402-6.0 DESIGN FACTORS

402-6.02 Structure Sizing [Rev. Mar. 2017]

410-5.01 Mechanically-Stabilized-Earth (MSE) Wall [Rev. Mar. 2017]

**Figure 409-2G
(Sheet 1 of 2)**

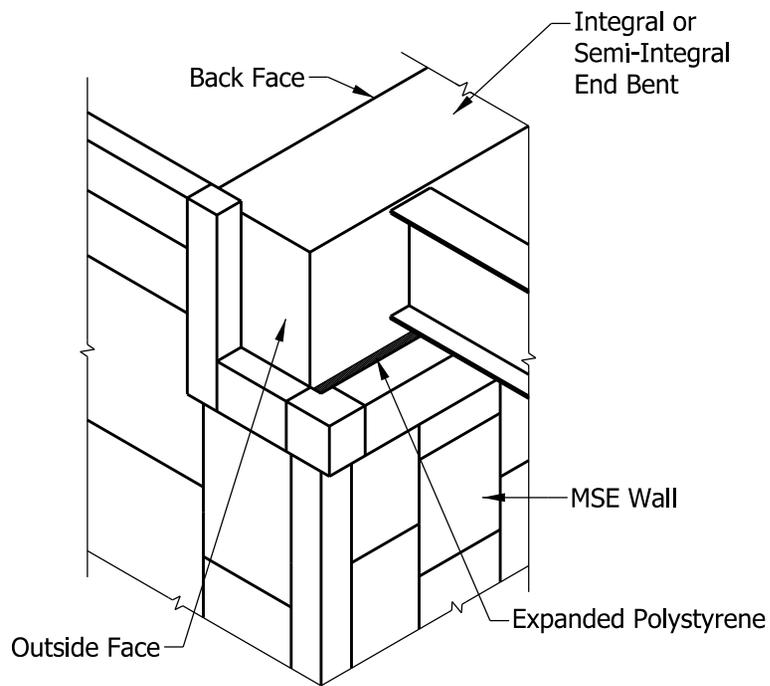
11. MSE Wall. If placed behind an MSE retaining wall, the end bent should be configured as shown in Figure [409-2G](#). See *LRFD* 11.10.8 and Section 410-5.0(07) of this manual for MSE wall drainage information.

If placed behind an MSE retaining wall, the end bent should be configured as shown in Figure [409-2G](#). See *LRFD* 11.10.8 and Section 410-5.0(07) of this manual for MSE wall drainage information.

MSE Wall at an End Bent. When an end bent is placed behind an MSE wall, expanded polystyrene should be shown for gap between the front face of the end bent and the back of the MSE wall. Do not show Styrofoam or extruded polystyrene. See Figure 409-2G, End Bent Placed behind MSE Wall for additional details.

Coarse aggregate and 6" end-bent drain pipe are not required to be specified separately for an end bent placed behind an MSE Wall.

Figure 409-2G
(Sheet 2 of 2)

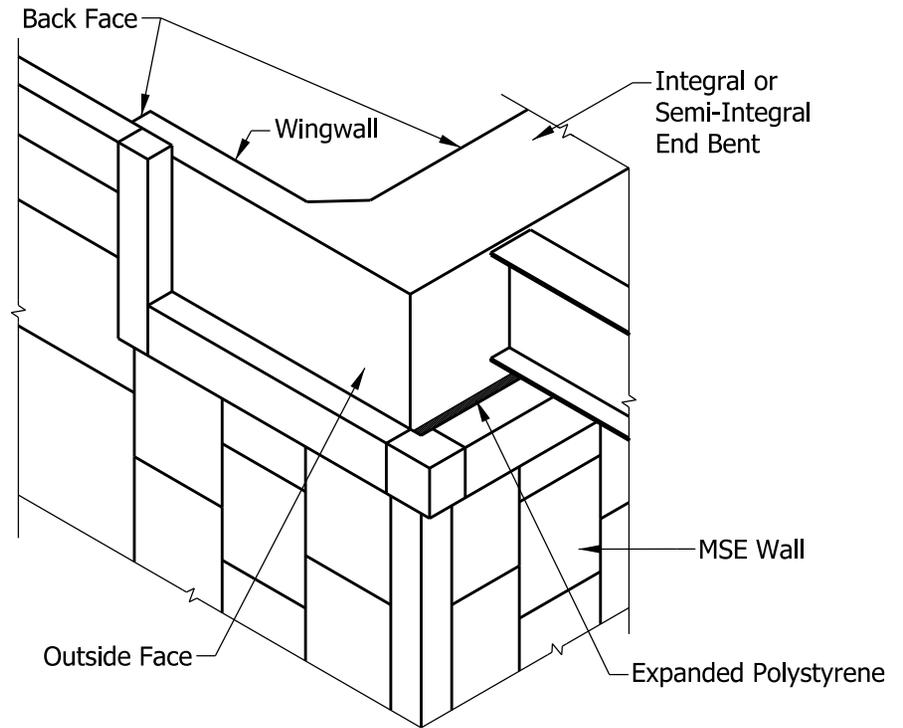
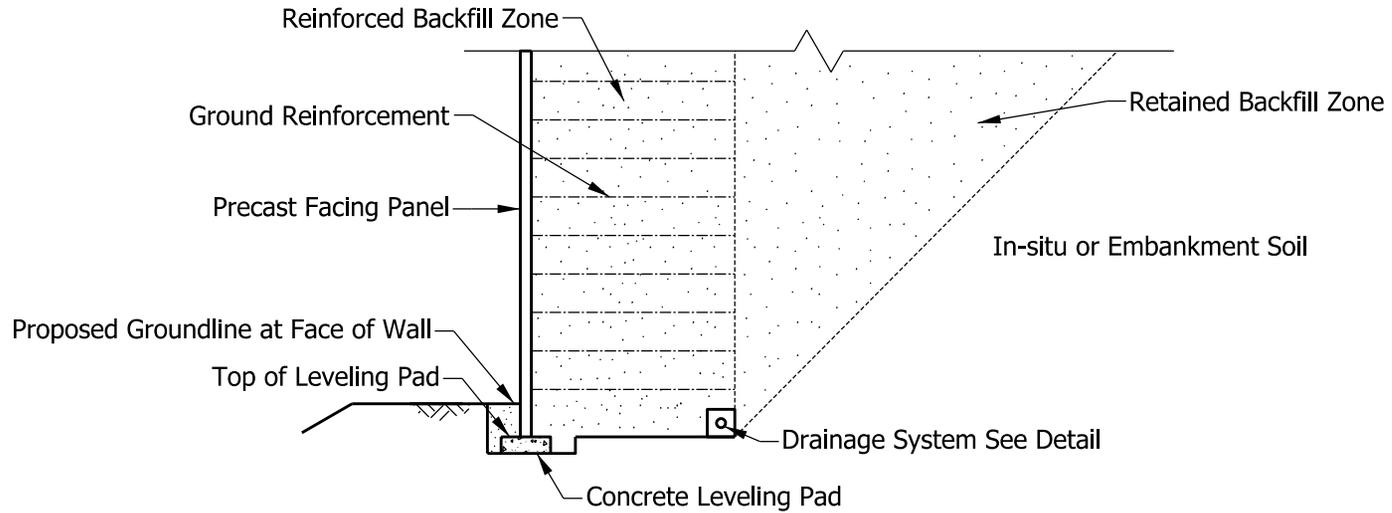
Where an MSE is placed parallel to the bridge approach roadway, it should be placed adjacent the outside face of the end bent or wingwall, but not cast against it. Sufficient clearance is needed to accommodate the thermal movement of the end bent. The MSE wall should not be placed abutting the back face of the end bent or wingwall.

Figure 410-5(0)C

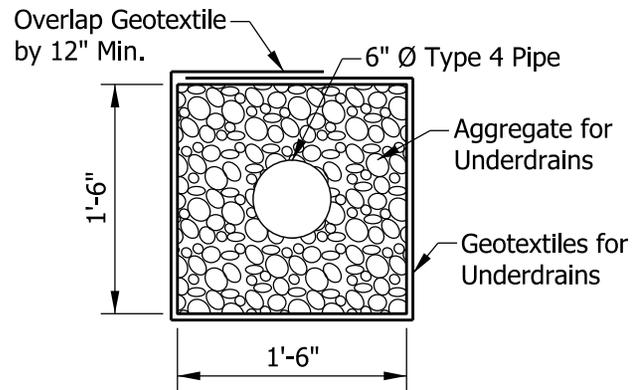
Drainage. Details for drainage of the surface-water infiltration and reinforced-soil backfill should be included for all MSE walls. Figure 410-5(0)C shows the standard drainage details. It is the designer's responsibility to determine the elevation of the drainage pipe such that it will drain and outlet adequately.
